TECHNICAL SERVICE BULLETIN

reissue No. **JTB00008v2/2006**

Subject/Concern:	Creak from Front Brake Caliper	
Model:		
The New XK - Normally Aspirated	VIN Range: B00379-B15857	
S-TYPE - Normally Aspirated and Diesel Only	VIN Range: N52048-N80901	
XJ Range - Normally Aspirated	VIN Range: G49701-H16364

E68484

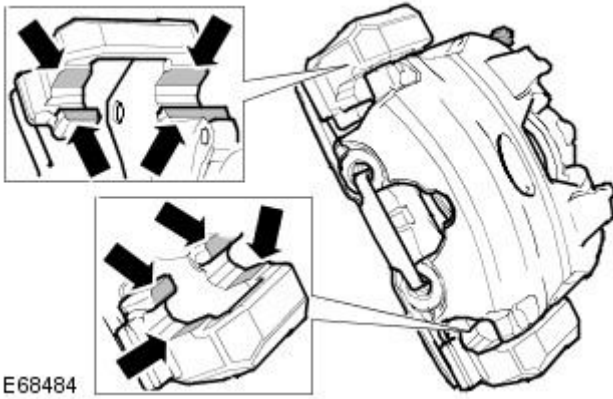
2. Clean and apply grease to the front brake caliper (see E68484).
